REMARKS

AMENDMENTS TO THE DRAWINGS

APPENDIX A
Replacement Drawing Sheets

FIG. 24

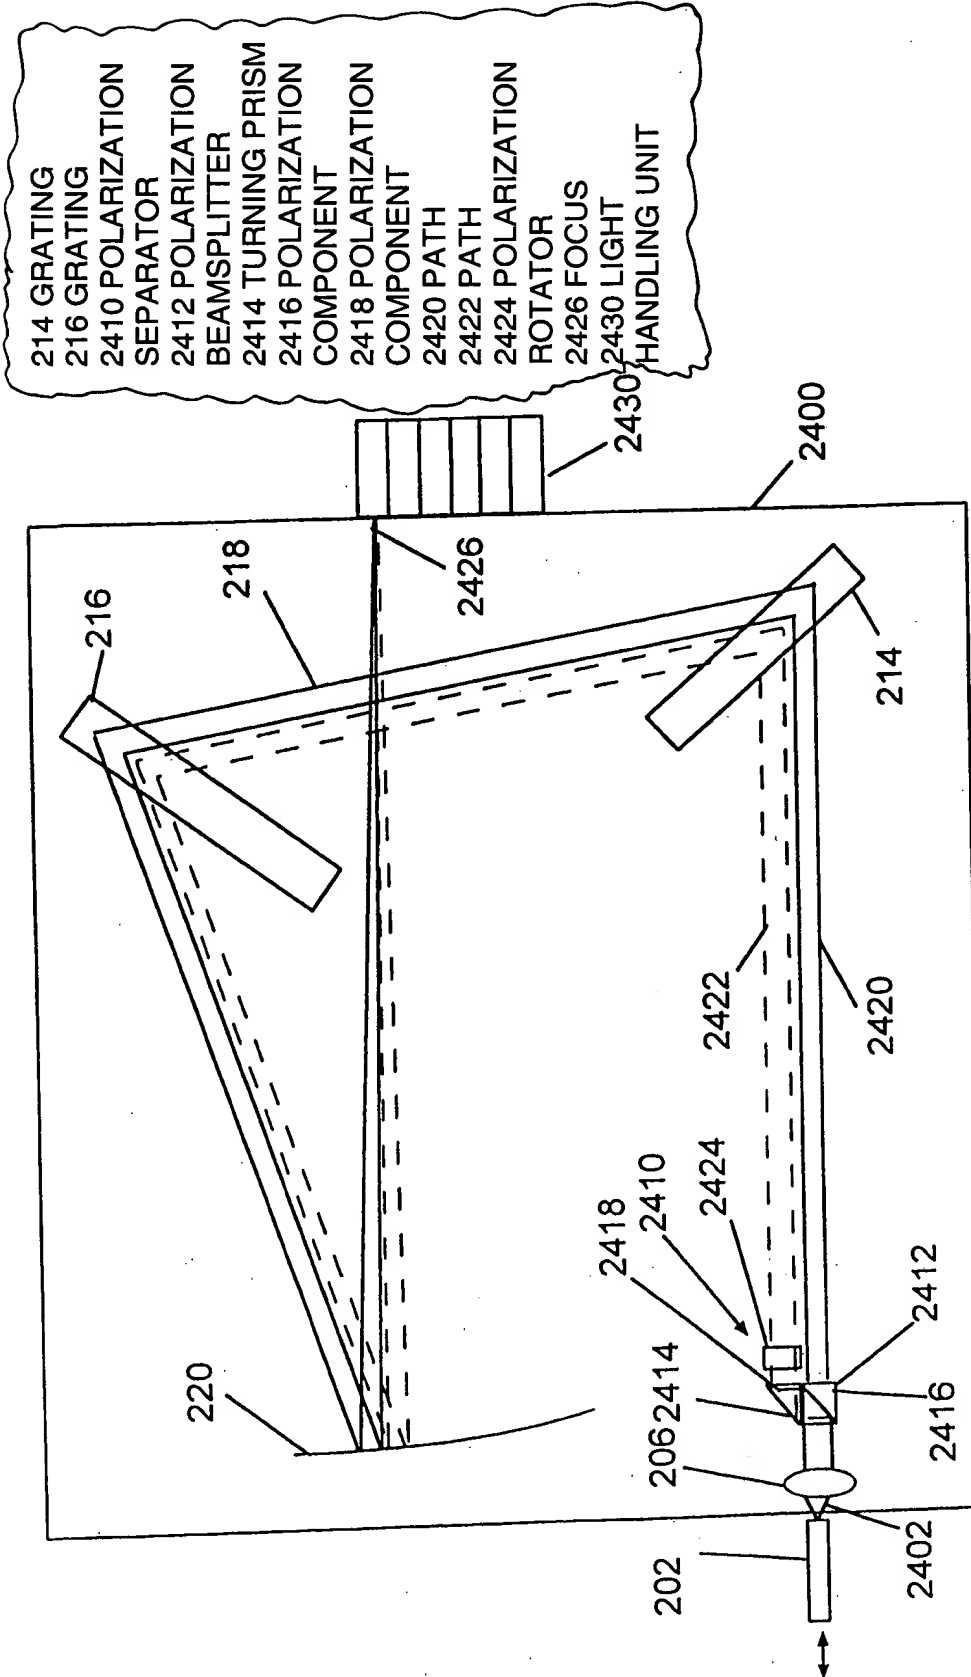
FIG. 24 was further objected to on the grounds that (a) reference numbers 2414 and 2418 are duplicate reference numbers for the same item; and (b) reference numbers 2416 and 2412 are duplicate reference numbers for the same item. The objection as to "(a)" should be withdrawn inasmuch as 2414 refers to a turning prism, and 2418 refers to a polarization component of a beam transmitted through the prism 2414. The objection as to "(b)" should be withdrawn inasmuch as 2412 refers to a polarization beamsplitter, and 2416 refers to a polarization component of a beam transmitted through the beamsplitter 2412.

- The ninth sheet which contains FIG. 24 replaces the prior replacement sheet that contains FIG. 24. FIG. 24 has been changed as required by the examiner. In addition, a few additional labels have been included to further improve understanding of the drawing.

FIG. 25B

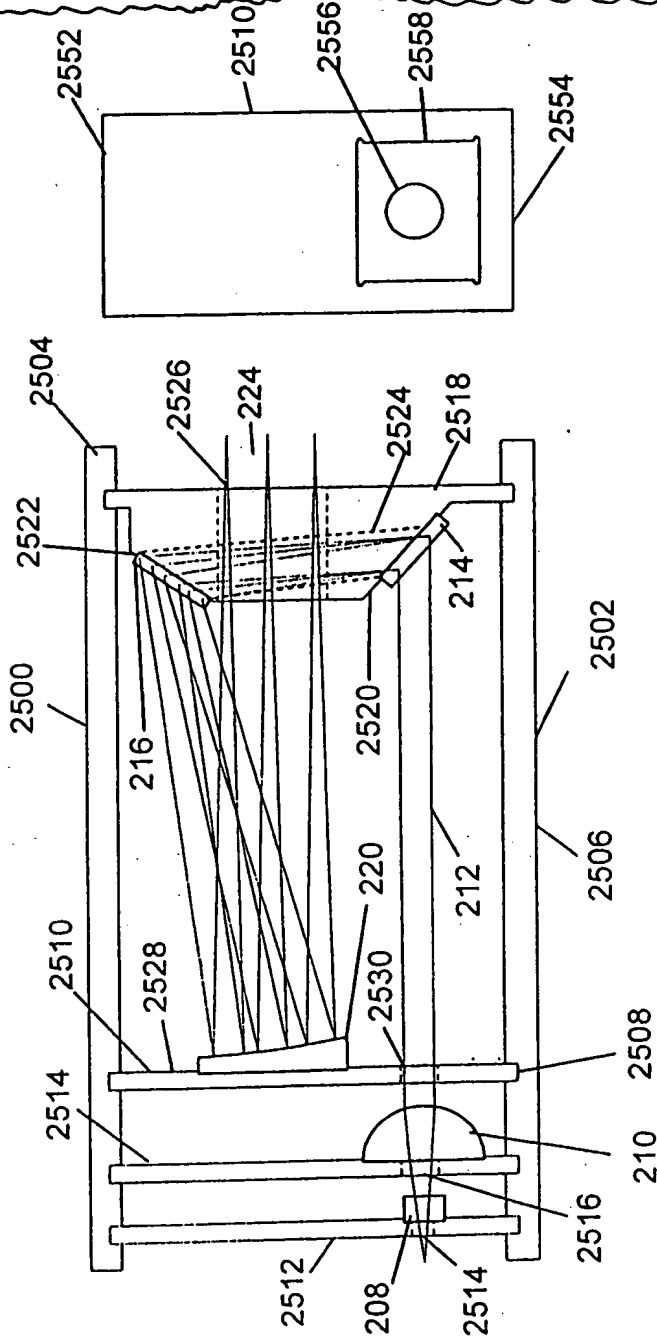
- The tenth sheet which contains FIGS. 25A and 25B replaces the original sheet that contains FIGS. 25A and 25B. FIGS. 25A and 25B have been changed as required by the examiner. In addition, a few additional labels have been included to further improve understanding of the drawing.

FIGS. 25A and 25B were further objected to on the grounds that (a) reference numbers 2506 and 2502 are duplicate reference numbers for the same item; (b) reference numbers 2510, 2528 and 2508 are duplicate reference numbers for the same item; and (c) reference numbers 2552, 2510 and 2554 are duplicate reference numbers for the same item. The objection as to "(a)" should be withdrawn inasmuch as 2502 refers to a frame, and 2506 refers to a lower rail of the frame 2502. The objection as to "(b)" should be withdrawn inasmuch as 2508 refers to multiple slots, 2510 refers to multiple mounting plates that may be fitted into the slots 2508, and 2528 refers to a particular one of the plates 2510. The objection as to "(c)" should be withdrawn inasmuch as 2510 is a generic representation of the multiple mounting plates, and 2552 and 2554 refer to upper and lower edges of the generic representation.

FIG. 28

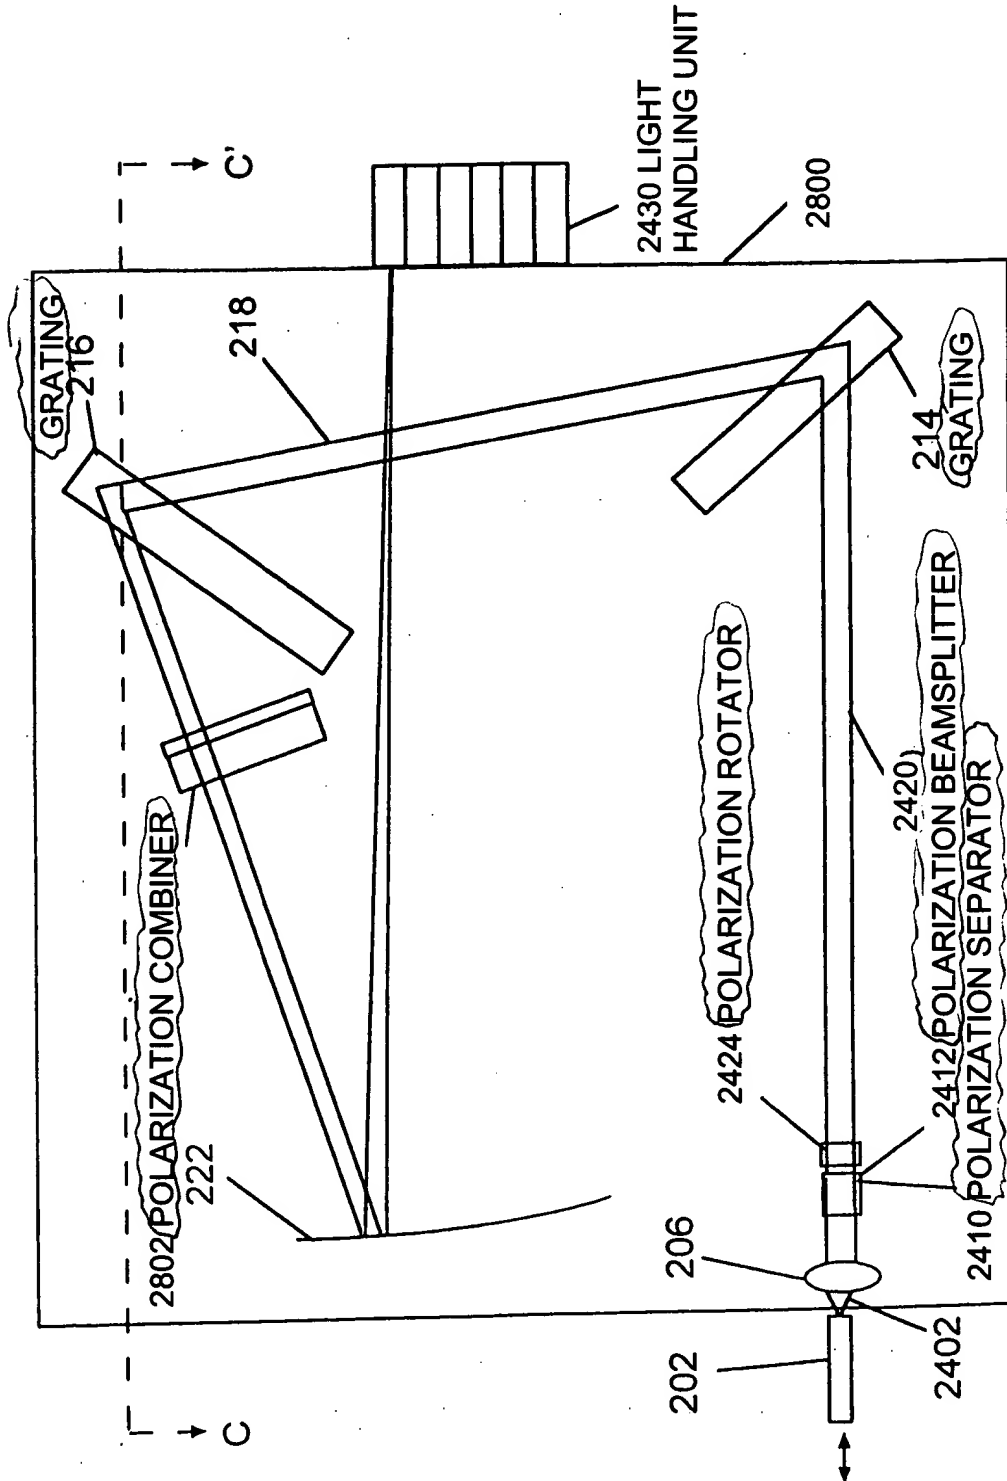
- The eleventh sheet which contains FIG. 28 replaces the prior replacement sheet that contains FIG. 28. FIG. 28 has been changed as required by the examiner.

FIG. 28 was further objected to on the grounds that reference numbers 2410 and 2412 are duplicate reference numbers for the same item. The objection should be withdrawn inasmuch as 2410 refers to a polarization separator, and 2412 refers to a polarization beamsplitter which is part of the polarization separator 2410.

FIG. 30

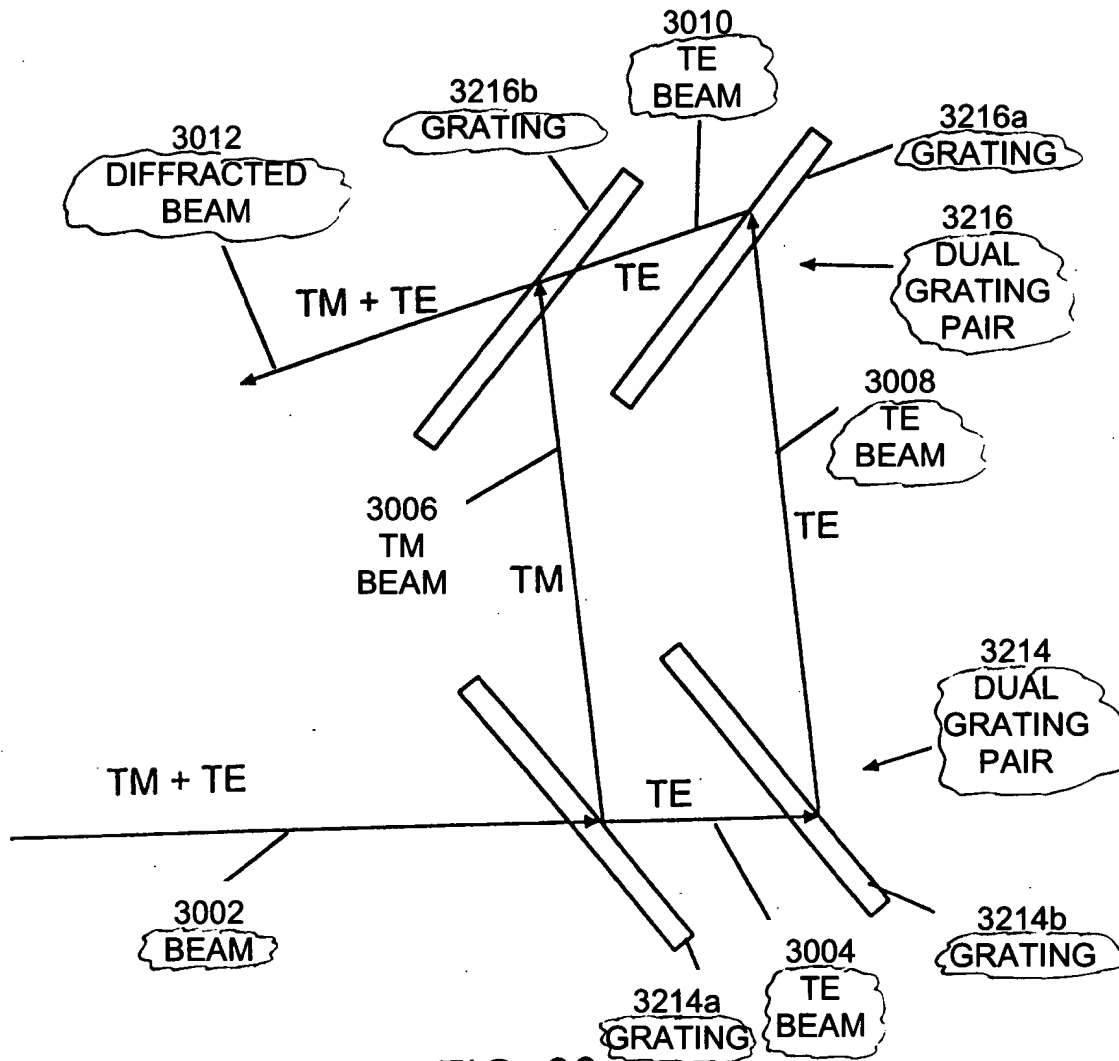
- The twelfth sheet which contains FIG. 30 replaces the original sheet that contains FIG. 30. FIG. 30 has been changed as required by the examiner.
- The thirteenth sheet which contains FIG. 34 replaces the prior replacement sheet that contains FIG. 34. FIG. 34 has been changed as required by the examiner.

FIG. 35A

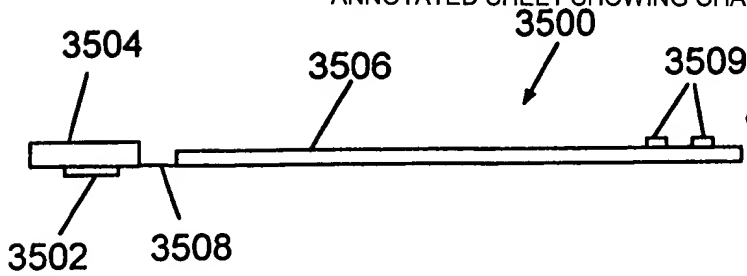
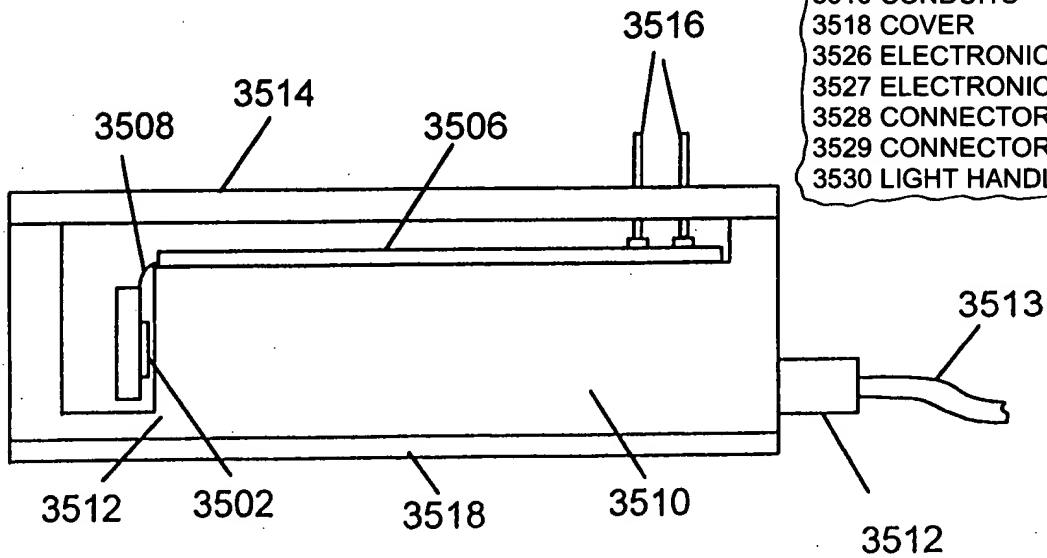
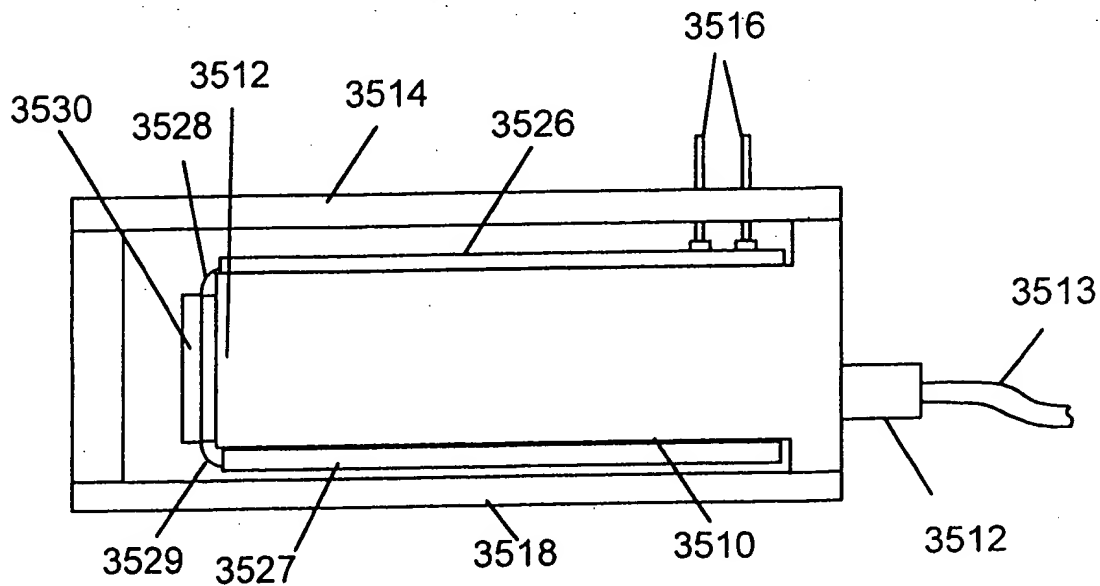
- The fourteenth sheet which contains FIGS. 35A-35C replaces the original sheet that contains FIGS. 35A-35C. FIGS. 35A-35C have been changed as required by the examiner.
